**Revision of Manuscript Number:** IEEE-TPWRS-01391-2021, version 1 January 2, 2022  
**Journal:** IEEE Transactions on Power Systems  
**Author:** Abhishek Halder, Kenneth F. Caluya, Pegah Ojaghi, Xinbo Geng

### Response to decision:

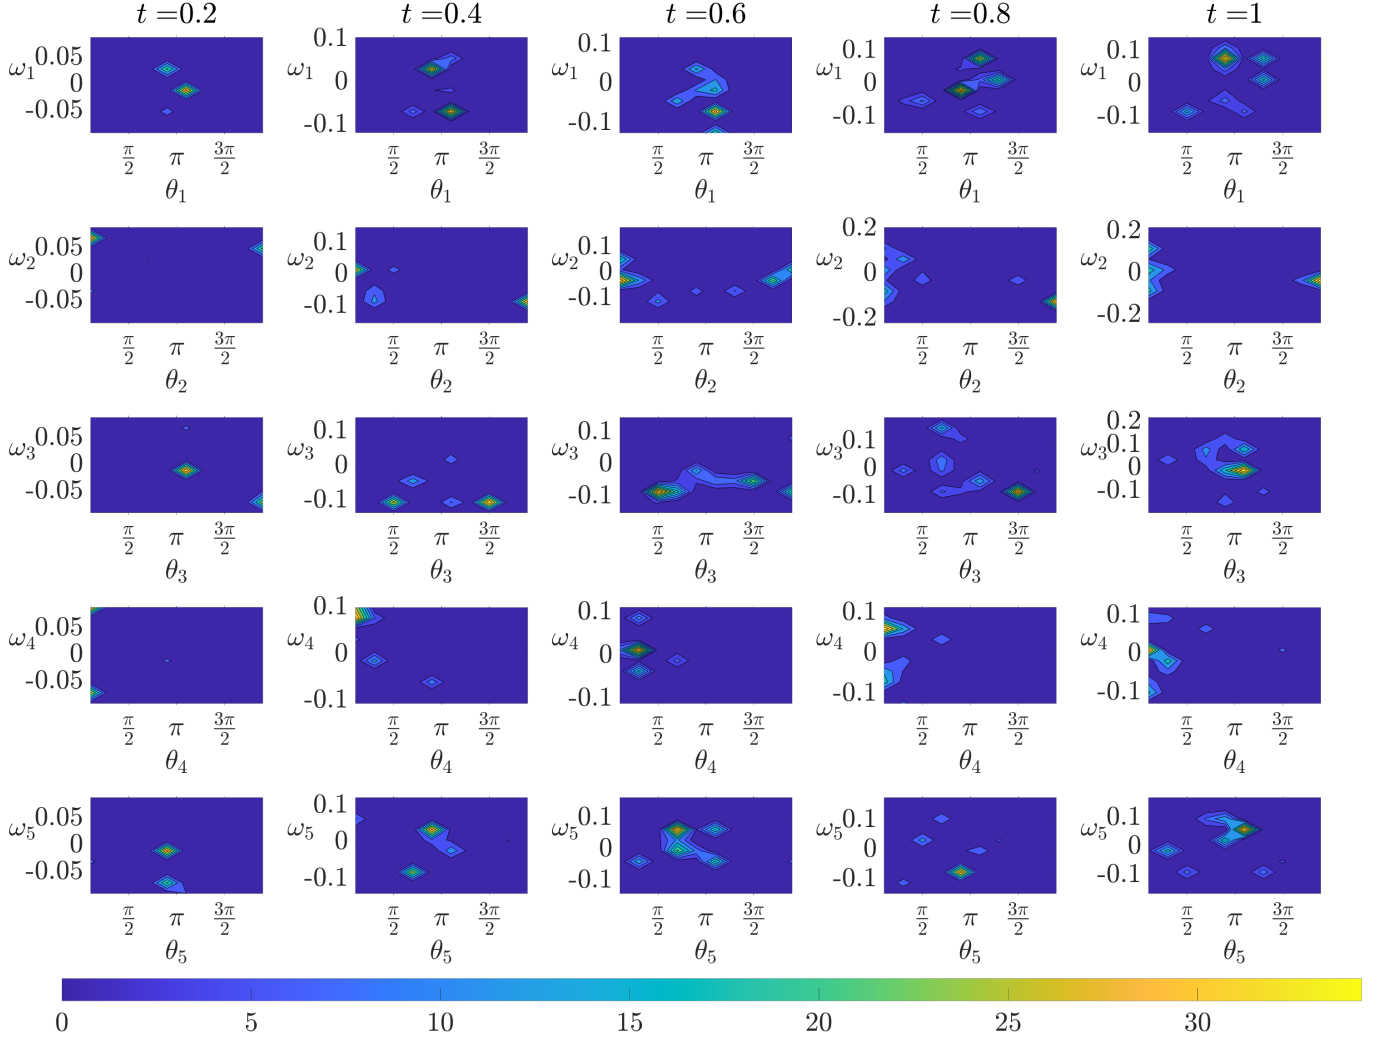
*Figures 5 and 6 are unreadable.*

**Response:** Thanks for this comment. In the previous version, the strict 10 page limit enforced small figure sizes. In the revised manuscript, Figures 5 and 6 are made larger. Also, the Fig. 6 in the revised manuscript shows the transient  $(\theta_i, \omega_i)$  bivariate marginals for all the five generators in Case II; the previous version showed the same only for the generator 4 (bus 6). We believe these changes have improved clarity.

Regarding the style of plots, we had considered plotting the bivariate marginals as planar contour plots (as in Fig. 1 in this rebuttal document) but decided against it because of the following two reasons.

*First, in our opinion, this kind of plot is scientifically misleading as they hide the fact that these bivariate marginal PDFs are not really supported on the plane, or the subsets thereof, but instead have cylindrical supports.* Our message that the proposed method explicitly accounts this manifold geometry in the computation, would be missed had we chosen to make the plots as per populist cognitive bias on behalf of the readers. That the planar plots evoke a sense of familiarity cannot be a scientific argument in favor of it.

*Second, the planar contour marginal plots require additional mental efforts from the readers to correctly parse the statistical information conveyed.* For instance, consider the fourth column, second row subplot in Fig. 1 in this rebuttal document. It is upon the reader to parse that the two high probability regions on the left and right of that subplot are actually referring to the same angular high probability region around  $\theta_2 = 0$  rad, thanks to the periodic boundary condition on the angular variable. Our philosophy of technical communication is that the onus is on the authors, not on the readers, to clarify the scientific information as correctly as possible. And yes, we are aware that many papers in the power system literature make plots in the rectangular domain ignoring the manifold nature of the support, which in our experience, continue to add pain to the graduate students and beginning researchers trying to decipher the statistical meaning conveyed in those plots. We prefer ours not be contributing to the accrual of such pain, and instead make plots that depict the variables as they are.
